## ASSESSMENT REPORT

### Commercial and Retail Development – Mount Street, North Sydney MP 08\_0241 MOD 5

This report is an assessment of a request to modify the Concept Approval MP08\_0241 for a commercial and retail development at 86-96 and 100 Mount Street, North Sydney.

**Figure 3:** Approved (left) and proposed (right) external alterations to the northern, Spring Street, elevation (source: Proponent (MOD 4 and MOD 5))

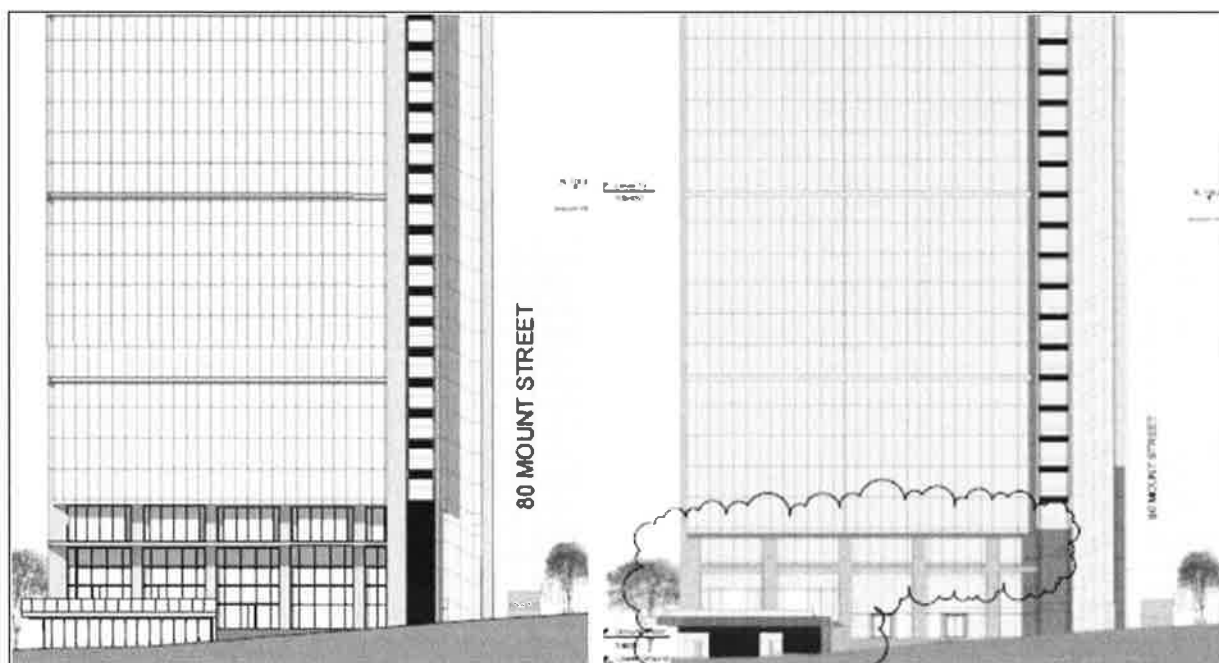
These changes can be seen in **Figures 5 – 8**. The above changes also result in alterations to the façade treatment of the building at ground, first and second floor levels, as shown at **Figure 3**.

- the additional GFA is minor, localised at ground and second floor levels, and does not significantly change the overall bulk and scale of the approved development;
- the extension of the ground levels to the Mount Street boundary is consistent with Council's DCP, which recommends a nil setback for building podiums;
- the revisions to the elevations maintain a high standard of design and appearance;
- there would be no significant amenity impacts on surrounding properties; and
- the additional office and retail floor space positively contributes to the growth of North Sydney's CBD as a commercial centre.

<b>Issue</b>	<b>Consideration</b>	<b>Recommendation</b>
<i>Increase in height</i>	<ul style="list-style-type: none"> <li>The modification includes an increase in the height of the roof level to match the height of the external parapets (refer to <b>Figure 4</b>). This also results in a corresponding increase in the height of the building maintenance unit (BMU) above the overall building height (from RL 199.70 to RL203.1).</li> <li>Although the proposal exceeds the maximum height control of RL 195 applicable to the site under <i>North Sydney Local Environmental Plan 2013</i>, the Department considers the proposed increase is minor and acceptable as: <ul style="list-style-type: none"> <li>the increased roof height would be entirely screened behind the approved parapet line;</li> <li>the BMU is centrally located within the roof and would not be visible from the surrounding streets or public domain;</li> <li>the modification would not result in adverse overshadowing or view loss impacts; and</li> <li>Sydney Airport has not raised any objection to the minor increase in height and has approved the penetration into the prescribed airspace.</li> </ul> </li> </ul>	No additional comments or amendments necessary.

**Figure 5:** Approved (top) and proposed (bottom) lower ground floorplan

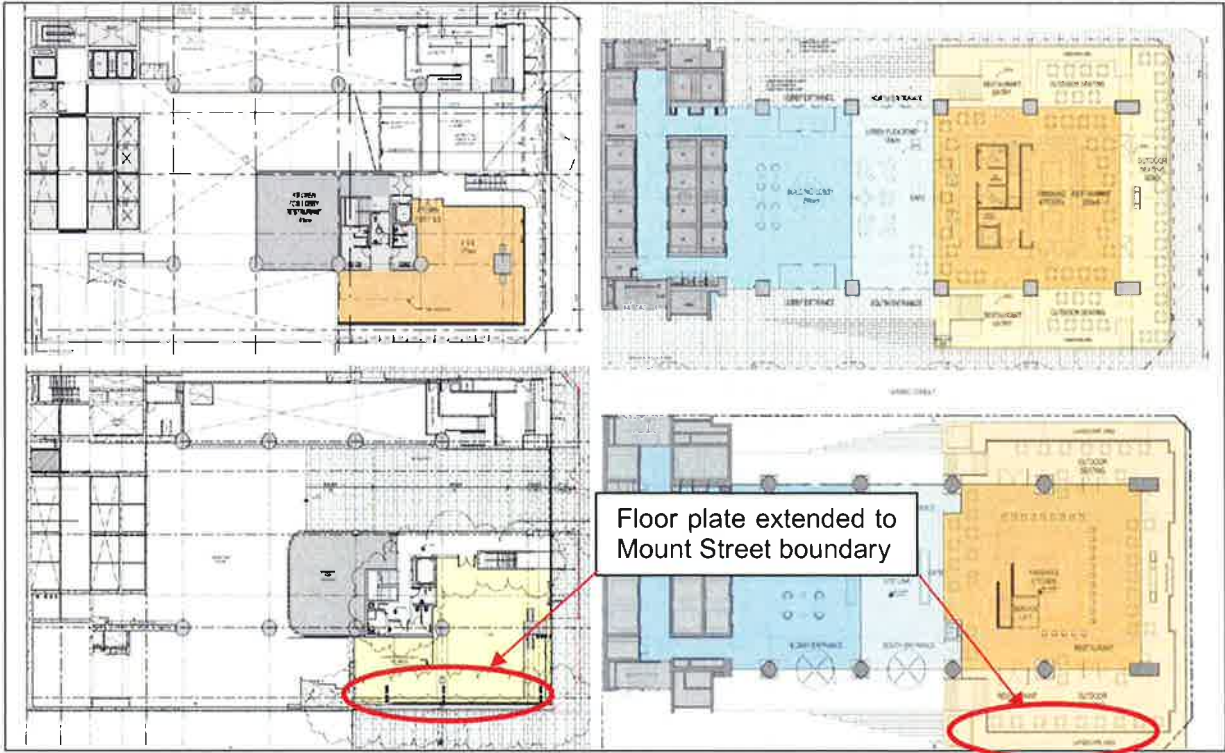
- enlargement of the ground floor level restaurant (and outdoor seating area) and lower ground level retail tenancy by extending the footprint to the Mount Street Boundary;
- provision of new plant room at level 1 and corresponding reduction of office accommodation at this level; and
- enlargement of level 1 mezzanine floorplate, rename as 'level 2', convert use of level from plant to office space.
